Product Change Notification – PCN # 000612

19 March 2019

EDR-G903 V1.2.0 changes to V2.0.0

EDR-G903-T V1.2.0 changes to V2.0.0

V1.2.0 design

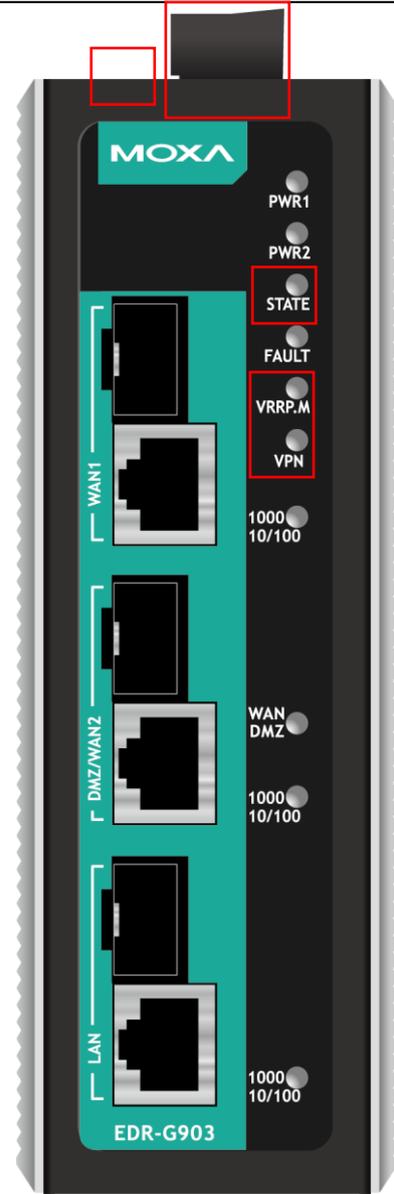
1. The terminal block is green.
2. There are no LEDs indicating system status, VRRP master and VPN connection status.
3. Reset button is in the bottom of system.

1. The terminal block is black.
2. Three LEDs are added for indicating system status, VRRP master and VPN connection status.
3. Reset button relocate to top of system.
